## IV • KRB STUDY REQUESTS

### KRB STUDY REQUEST 1: *Aesthetic Flows*

#### RESPONSE TO COMMENTS

### **KRB SR-1: AESTHETIC FLOWS UPDATED STUDY PROPOSAL**

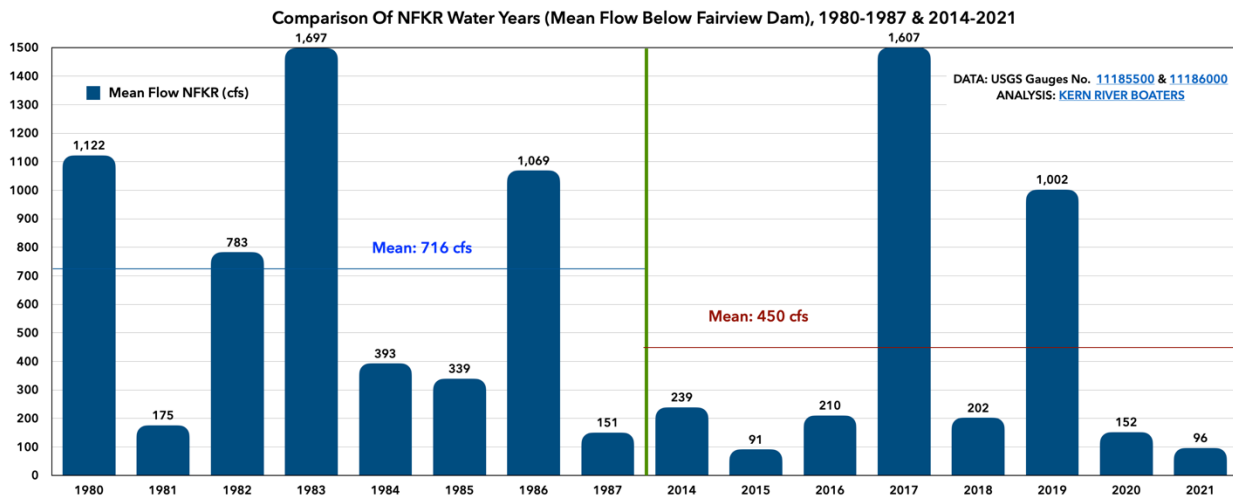
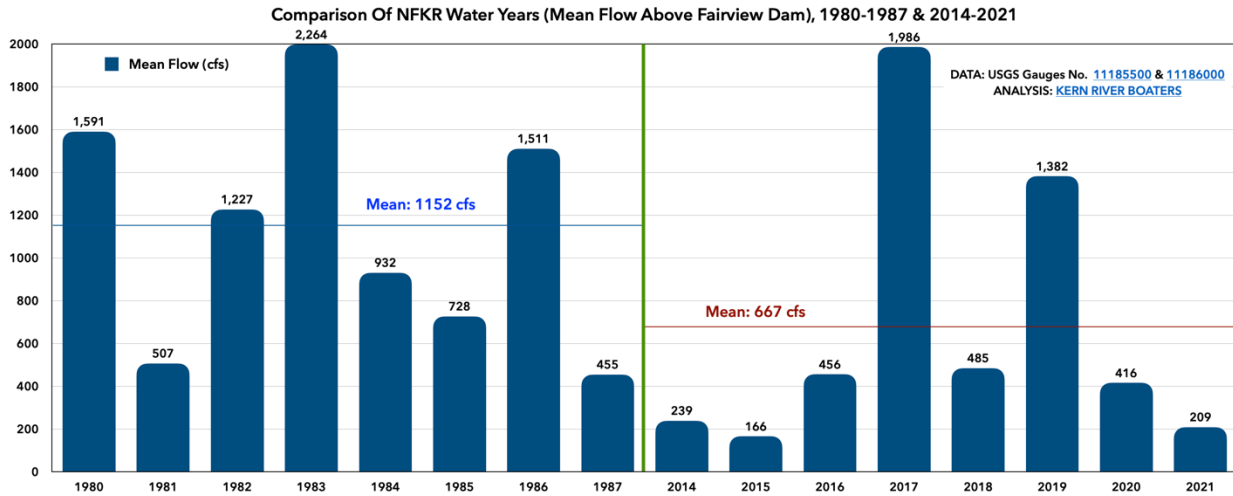
**KRB:** The “problem” is the result of Edison dewatering the NFKR to levels far below the lowest levels of natural flow. Over the existing POR (WY 1997-2021), the daily average flow above Fairview Dam fell below 125 cfs just 5% of the time. Flows that low are objectively rare for this river corridor. By contrast, flows in the dewatered reach below Fairview Dam fell below 125 cfs 44% of the time due to project operations. That number would have been even higher had the project not been offline for repairs so often (completely offline for 1,506 of the 9,131 days in the POR, and partially offline for at least hundreds more). Project operations turn what are rare low flow conditions on the NFKR into a routine, near-majority of days occurrence. It is reasonable to expect such dewatering to have a negative effect on the river as experienced by the humans who live in or visit that environment: the river was formed under a natural hydrograph; an unnaturally impaired hydrograph can render that formation aesthetically displeasing. Dewatering the river at Fairview Dam narrows the waters below, dries the riverbanks, exposes rocks in the riverbed that would otherwise be covered, reduces water speeds, lowers pool heights, eliminates many riffle sections, and increases areas covered with algae and other pond scum.

As for the 1982 USFS study team’s opinion that Fairview Dam “does not greatly alter the free-flowing character of the river” below, it is important to note that this judgment was essential to the eligibility of the dewatered reach as a Wild and Scenic River — without it, the reach would have been ineligible.<sup>151</sup> This was accordingly a functional judgment reflecting the relatively small size of the dam and its impoundment as well as the lack of river course alteration. A fair reading of the 1982 FEIS reveals it does not have much to say about aesthetics or visual quality based on existing flow levels in the dewatered reach; it offers no aesthetic judgment. Furthermore, flows at the time of the study and designation were much higher than those recently experienced in this drainage:

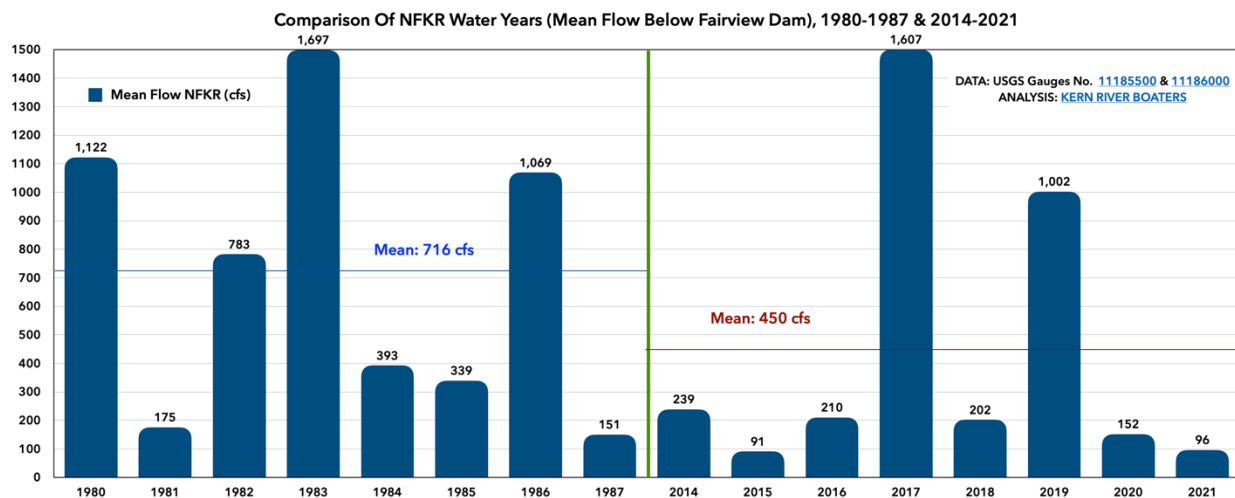
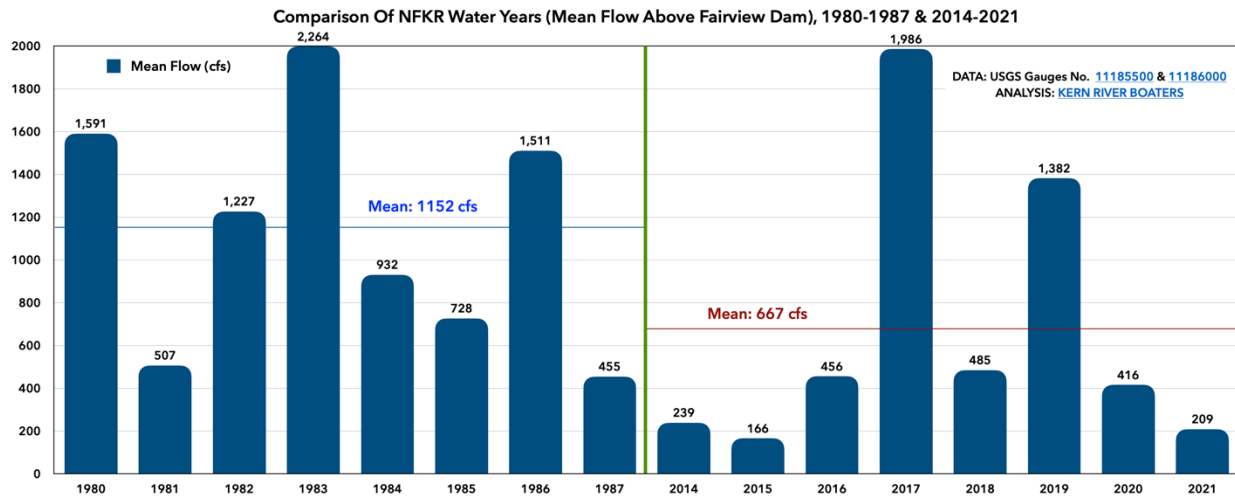
Edison routinely dewateres the NFKR to levels far below the lowest levels of natural flow. Over the existing POR (WY 1997-2021), the daily average flow above Fairview Dam fell below 125 cfs just 5% of the time. Flows that low are objectively rare for this river corridor. By contrast, flows in the dewatered reach below Fairview Dam fell below 125 cfs 44% of the time due to project operations — almost half the time. That number would have been even higher had the project not been offline for repairs so often (completely offline for 1,506 of the 9,131 days in the POR, and partially offline for at least hundreds more). Project operations turn what are rare low flow conditions on the NFKR into a routine, near-majority of days occurrence. It is reasonable to expect such dewatering to have a negative effect on the river as experienced by the humans who live in or visit that environment: the river was formed under a natural hydrograph; an unnaturally impaired hydrograph can render that formation aesthetically displeasing. Dewatering the river at Fairview Dam narrows the waters below, dries the riverbanks, exposes rocks in the riverbed that would otherwise be covered, reduces water speeds, lowers pool heights, eliminates many riffle sections, and increases areas covered with algae and other pond scum. The following images depict the dewatered reach with about 50 cfs in the riverbed on a day when 550 cfs was incoming at Fairview Dam:
